Office Action Summary

10/002,141

BEECK ET AL.

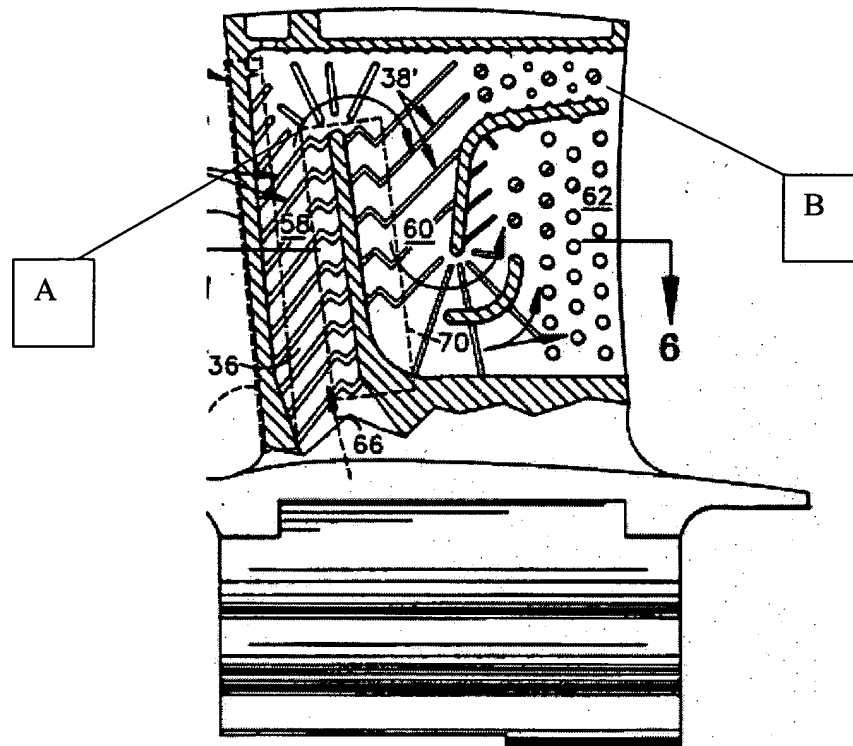
Claims 3-4 and 16 are rejected under 35 U.S.C. 103(a) as being unpatentable over Abdel-Messeh 5,052,889 in view of Glezer 5,603,606. Please see the annotated figure below. Abdel-Messeh (figure 5) discloses a component of a fluid flow machine substantially as claimed, including a coolant passage comprising at least one curved flow section A configured to curve in a first flow direction to establish coolant medium flow in the first flow direction, and a second passage B comprising an unnumbered inspection aperture, with the second passage branching off the coolant passage at the curved flow section and being arranged to extend in the first flow direction along a flow path which is tangential to the curved flow section. The component is a rotating blade for a turbine, the inspection aperture is arranged in the neighborhood of a tip of the blade, and the inspection aperture is arranged at the blade tip and has its longitudinal axis essentially parallel to an axis of the fluid flow machine.

However, Abdel-Messeh does not disclose that the second passage B is arranged and dimensioned to enable the introduction of a borescope through the inspection aperture and the second passage. Rather, the second passage has obstructions inside.

Glezer shows a cooled turbine blade 114 having tip passage 170 and an inspection aperture 178, with the tip passage being free of any flow obstructions, for the purpose of providing a smooth flow of cooling fluid along the tip and out of the blade at the tip. The tip passage is arranged and dimensioned to enable the introduction of a borescope through the inspection aperture and the second passage, since these are a function of the size of the borescope, and the size of the borescope would determine whether or not it would be able to be introduced into the inspection aperture. A miniaturized borescope having a tiny diameter would be capable of being introduced into the inspection aperture.

It would have been obvious at the time the invention was made to a person having ordinary skill in the art to form the second passage B of Abdel-Messeh such that it is unobstructed and thus that it is arranged and dimensioned to enable the introduction of a borescope through the inspection aperture and the second passage, as taught by Glezer.
